ADDENDUM NO. 3 – May 18, 2026

**Missionary Minnie Lee Cotton Park Restroom
CIP PK 26-21**

This addendum amends the Contract Drawings and Specifications for this project as follows:

1 DEMOLITION SITE PLAN
 1/16" = 1'-0"

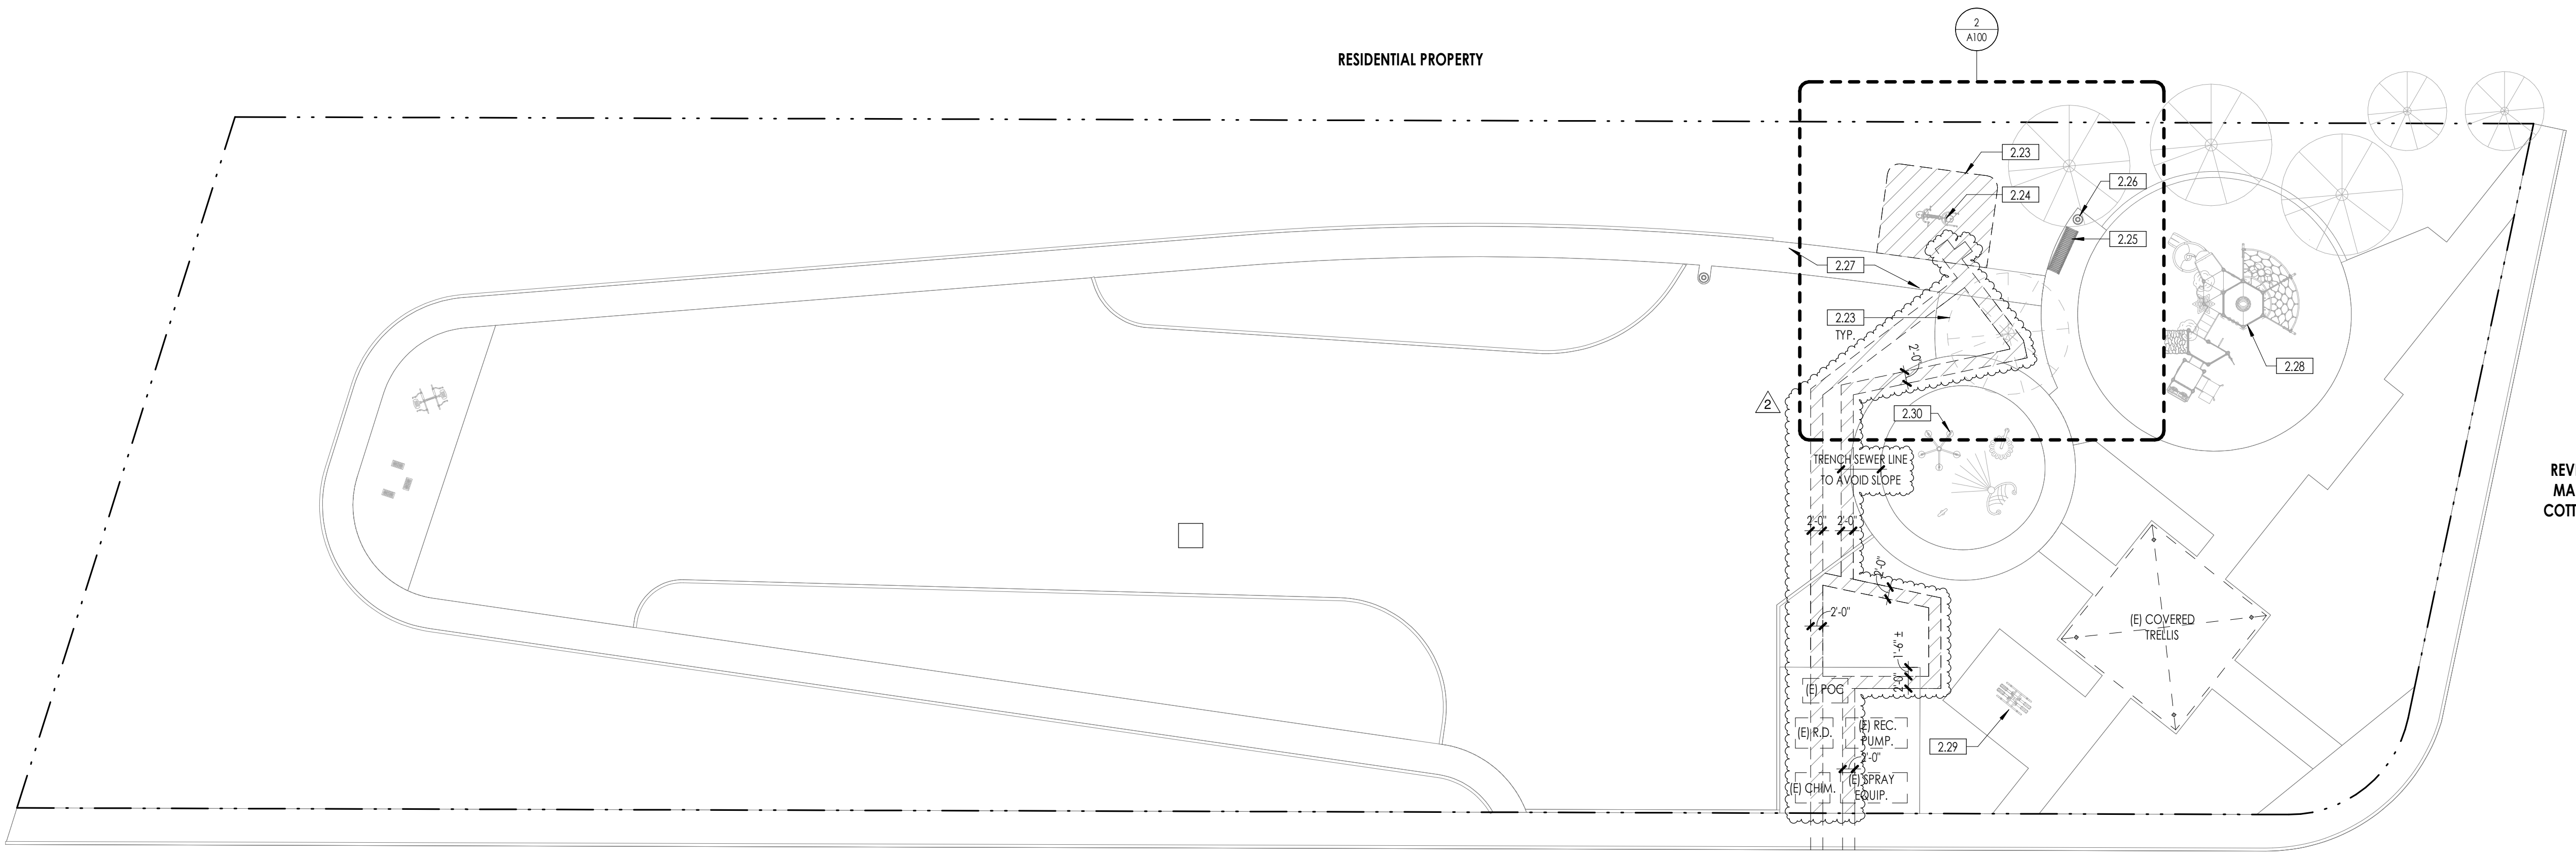
RFI 3: Key Notes 2.24 through 2.30 are missing from Sheet A100

A3: The following key notes apply and will be added to Sheet A100

2.24 (E) EXERCISE EQUIPMENT TO BE RELOCATED

2.25 (E) BENCH TO REMAIN

2.26 (E) LAMP POST TO REMAIN

2.27 (E) FLATWORK TO REMAIN

2.28 (E) PLAY STRUCTURE TO REMAIN

2.29 (E) EXERCISE EQUIPMENT TO REMAIN

2.30 (E) SPLASH PAD TO REMAIN

1 DIMENSION FLOOR PLAN
 A210 3/8" = 1'-0"

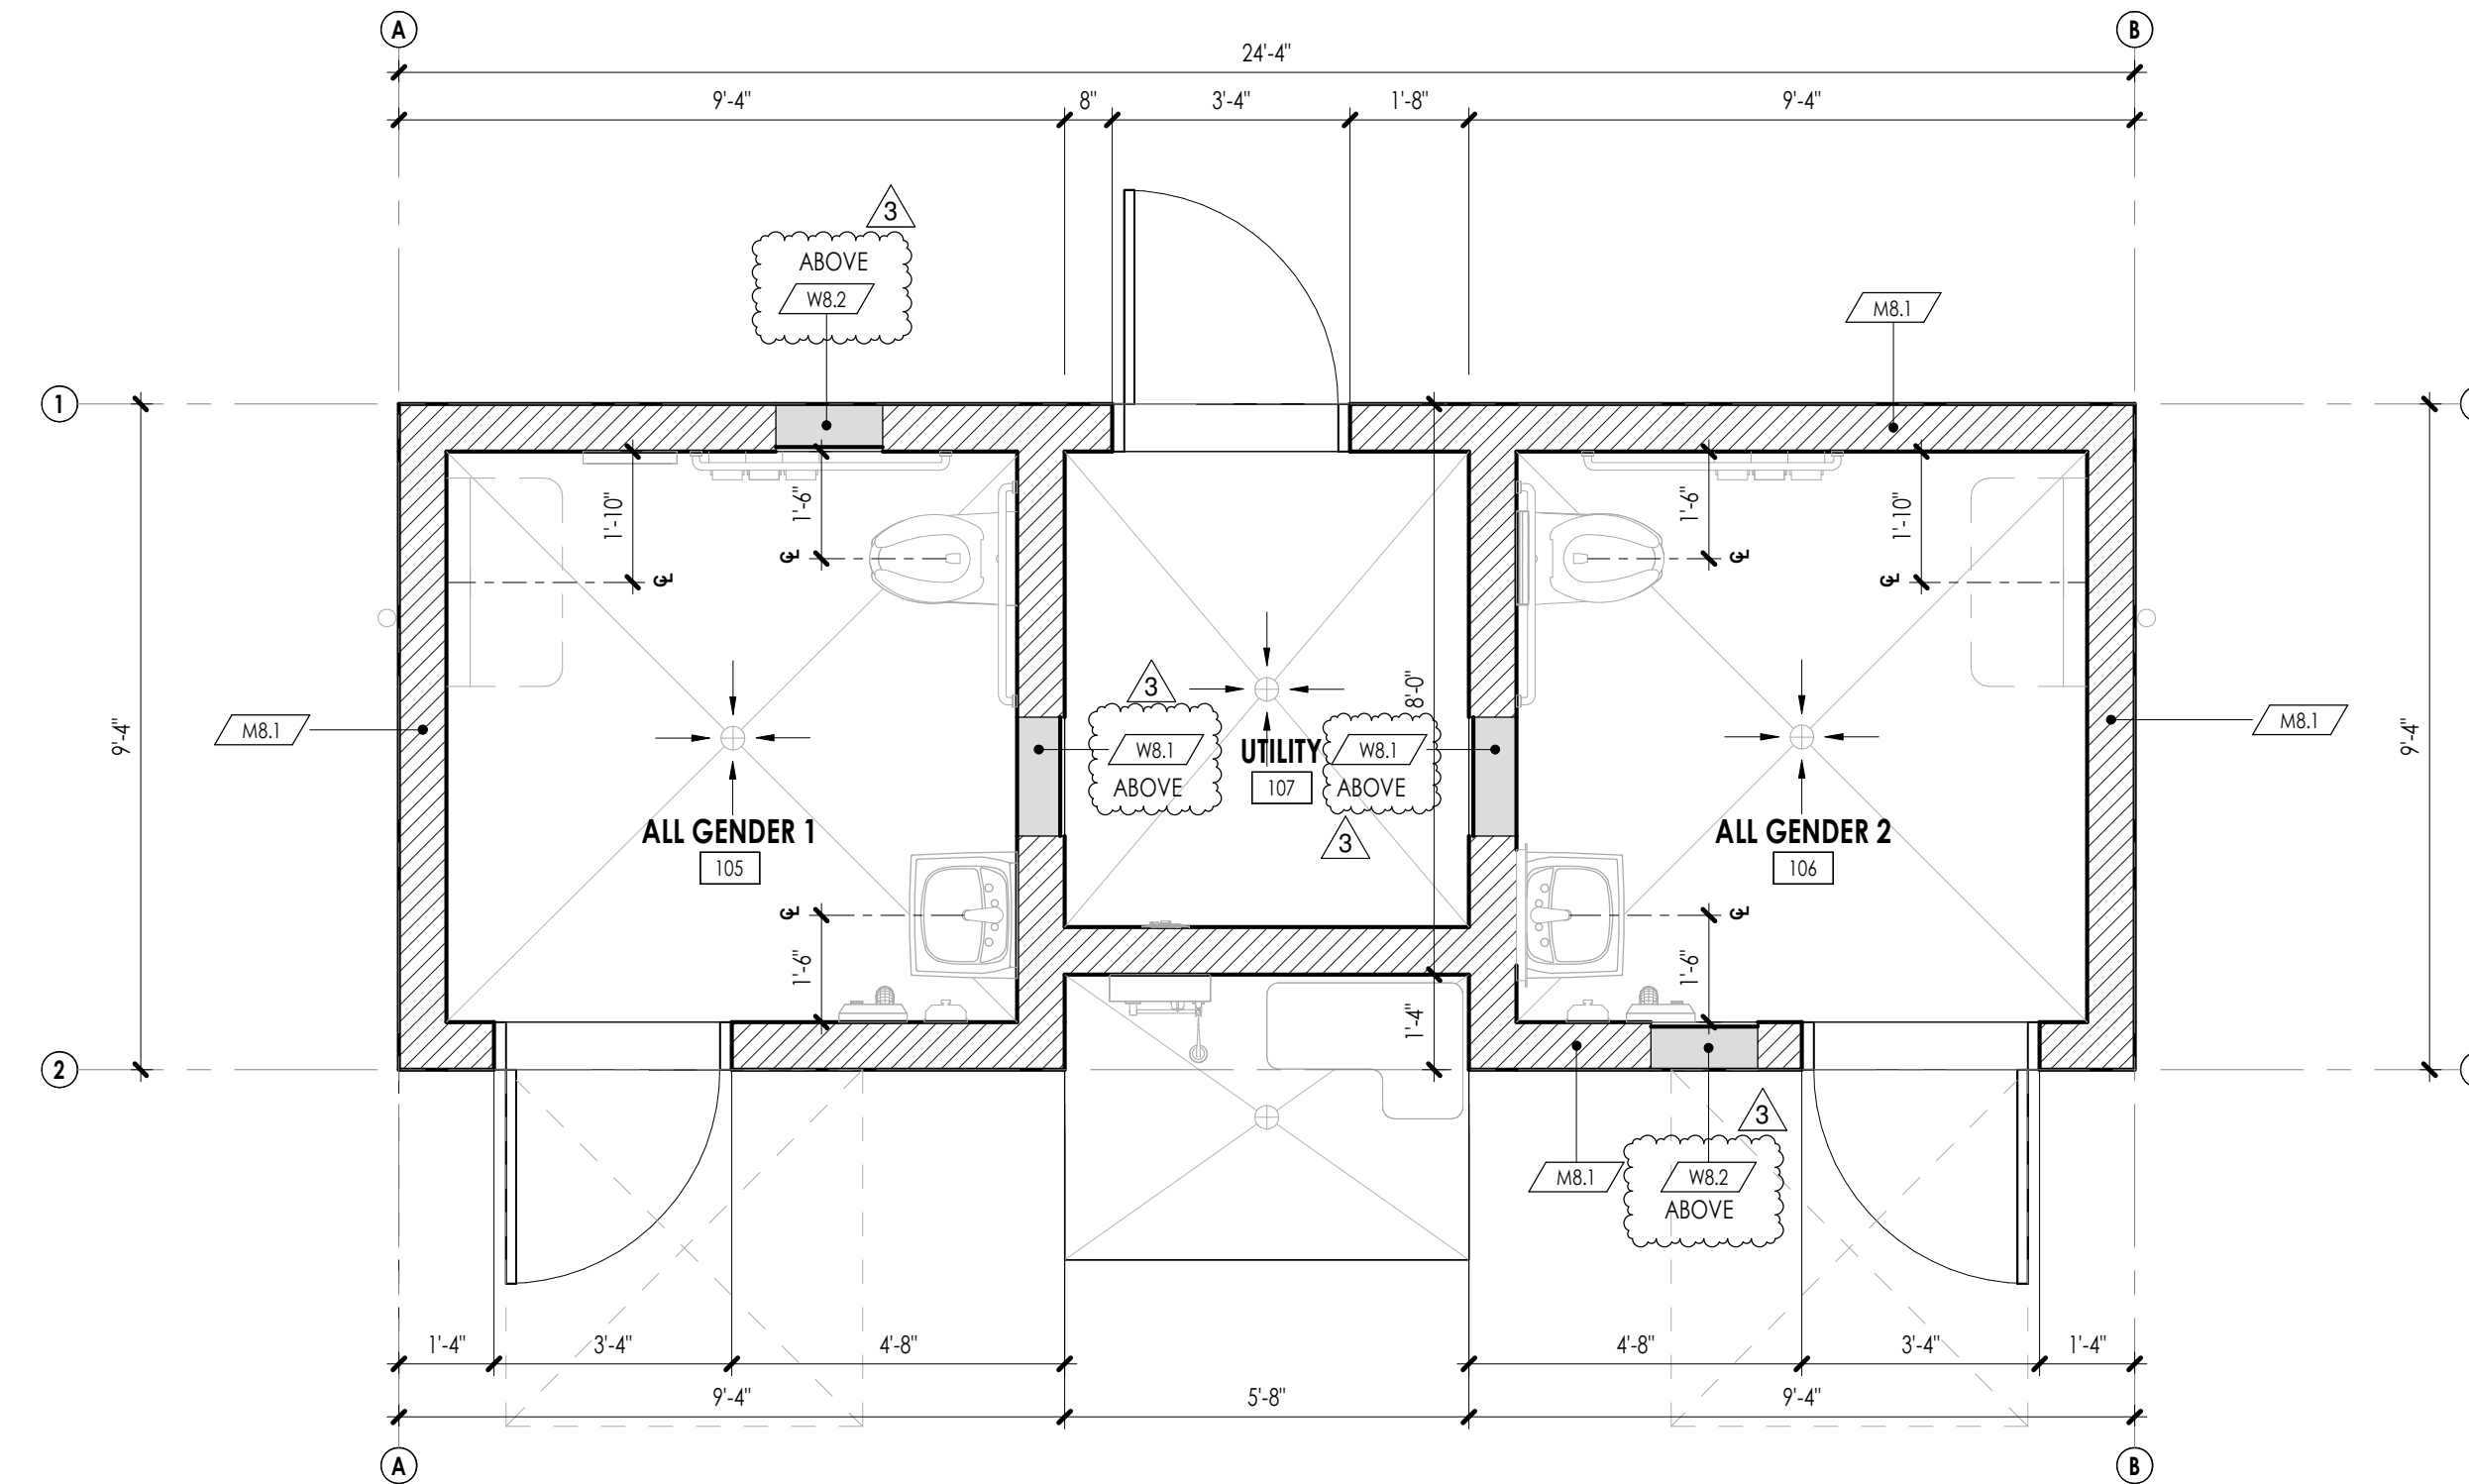
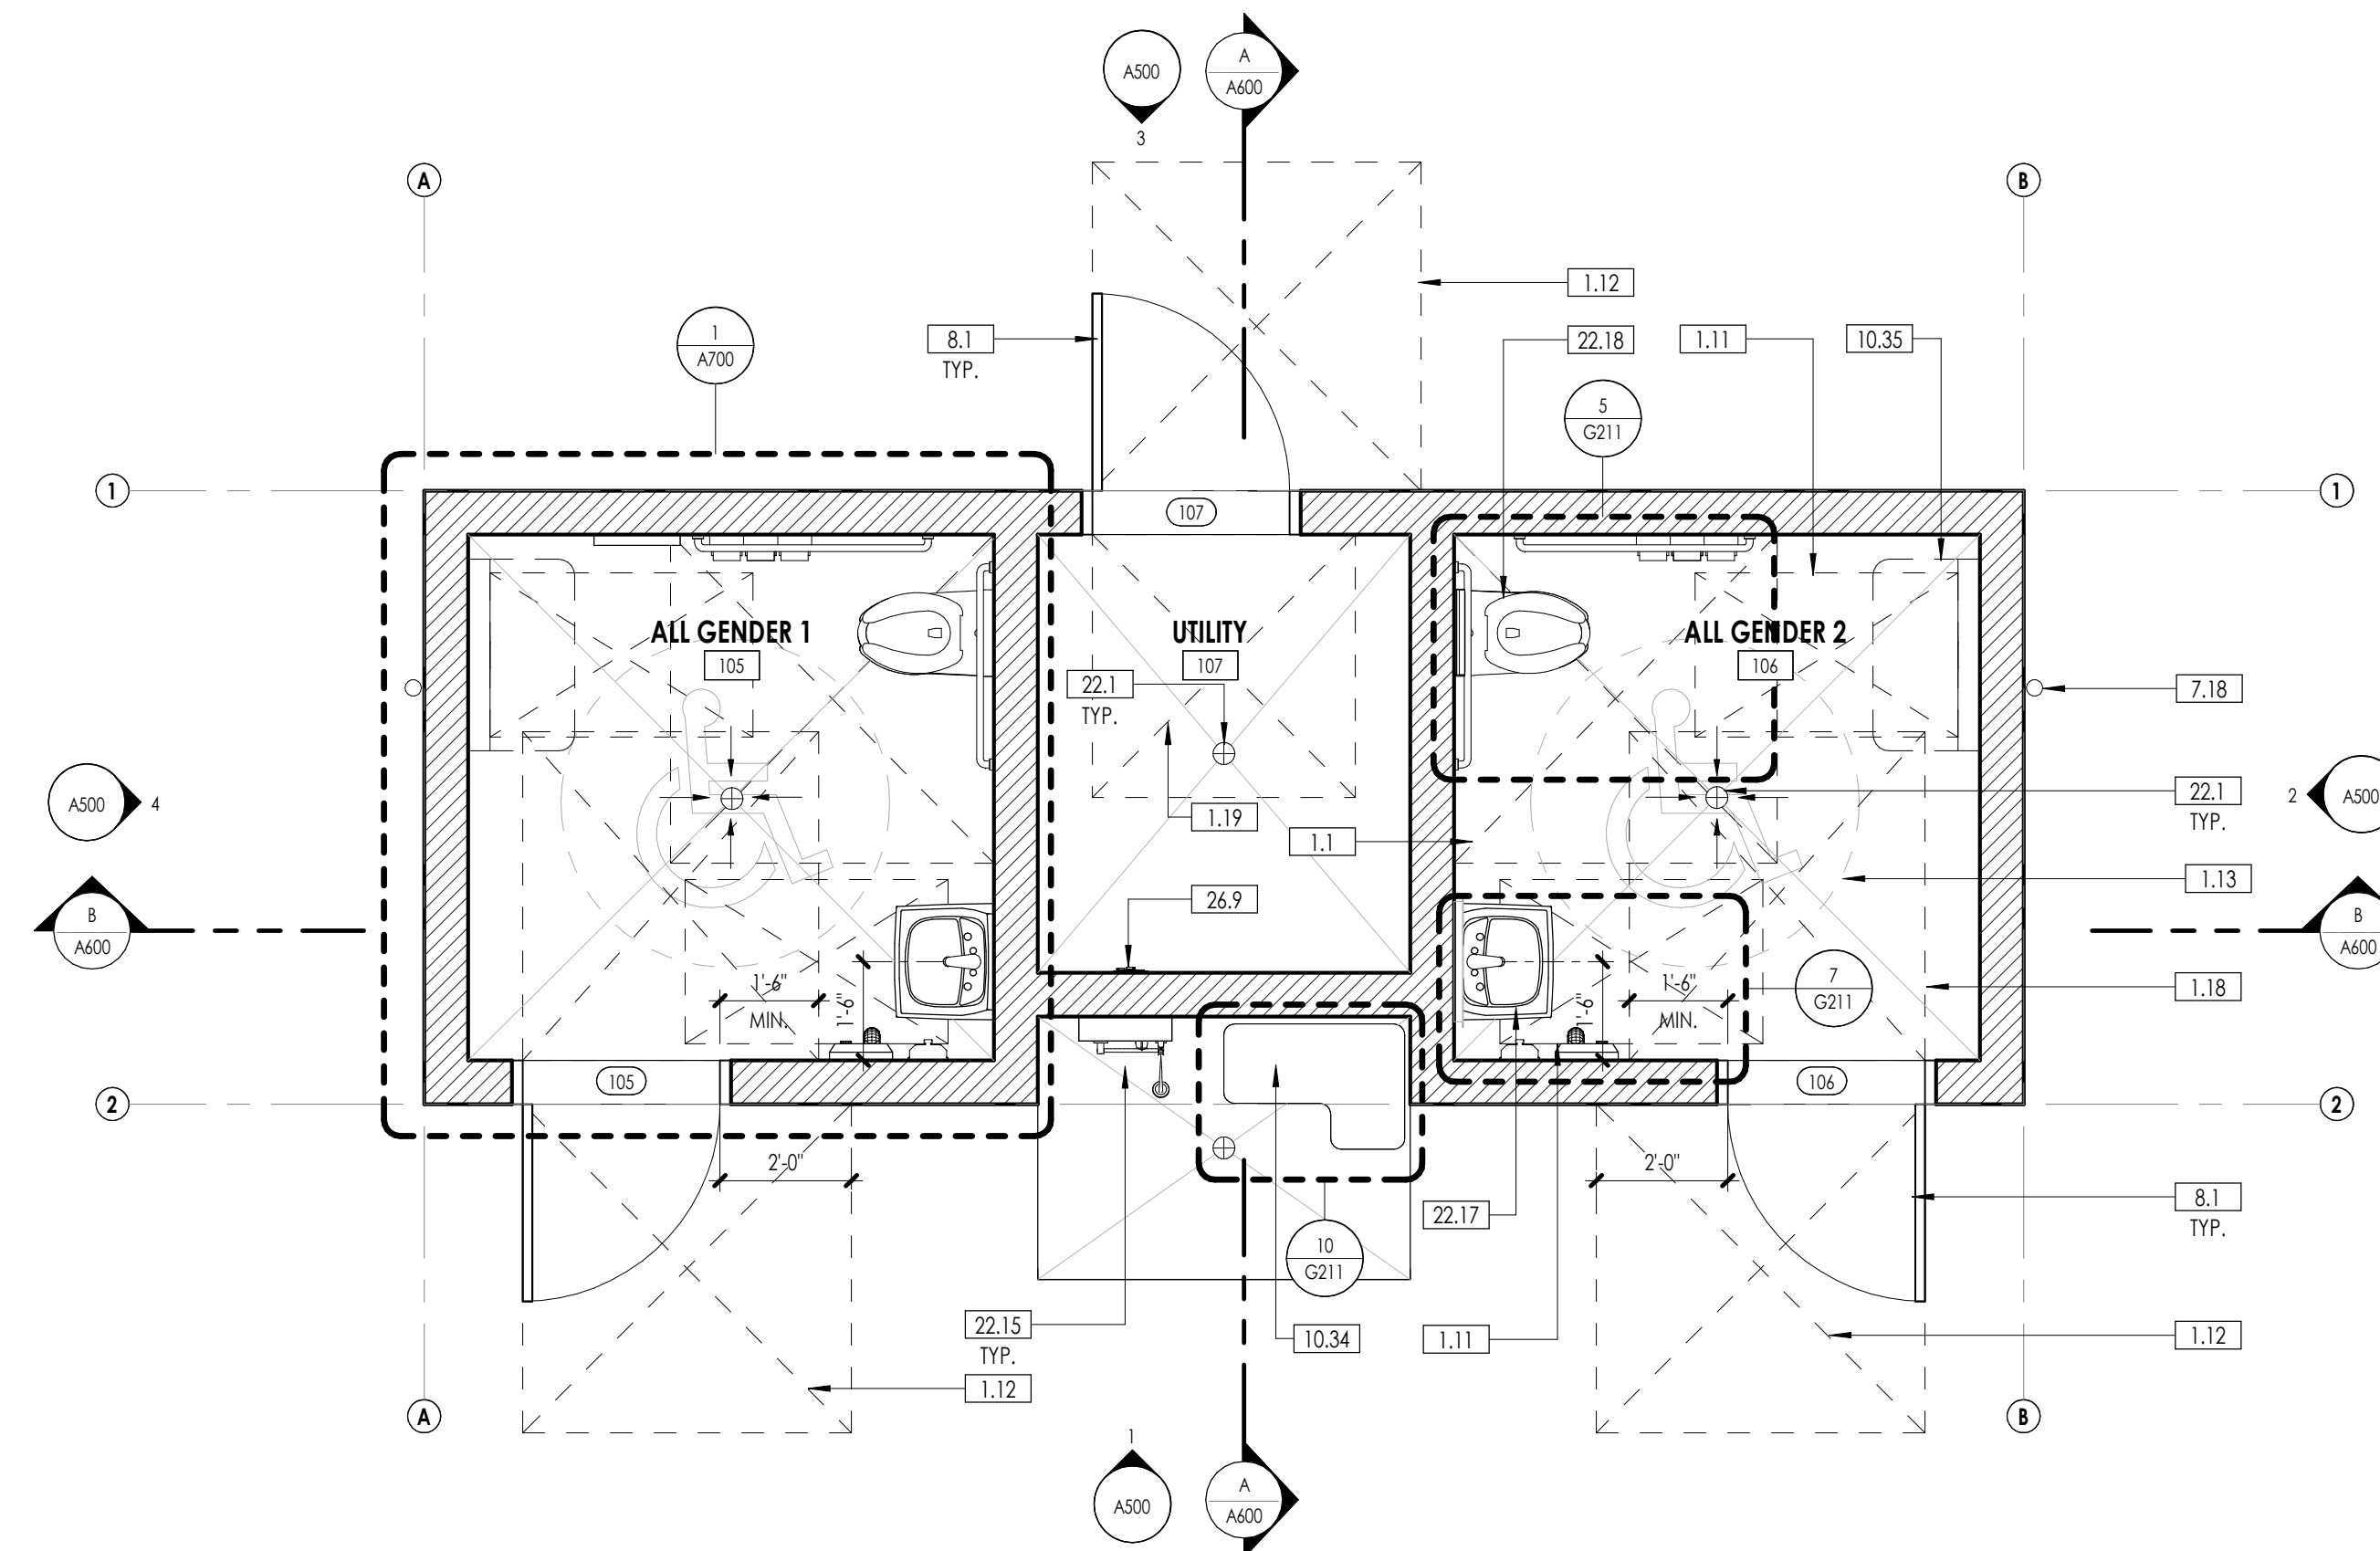
RFI 4: Detail 1 on Sheet A210 has wall type tags but no corresponding call outs.

A4: Refer to the attached revised Sheet A210. Wall tags have been corrected and are now properly referenced in the wall type schedule, as well as the call-out for the CMU block.
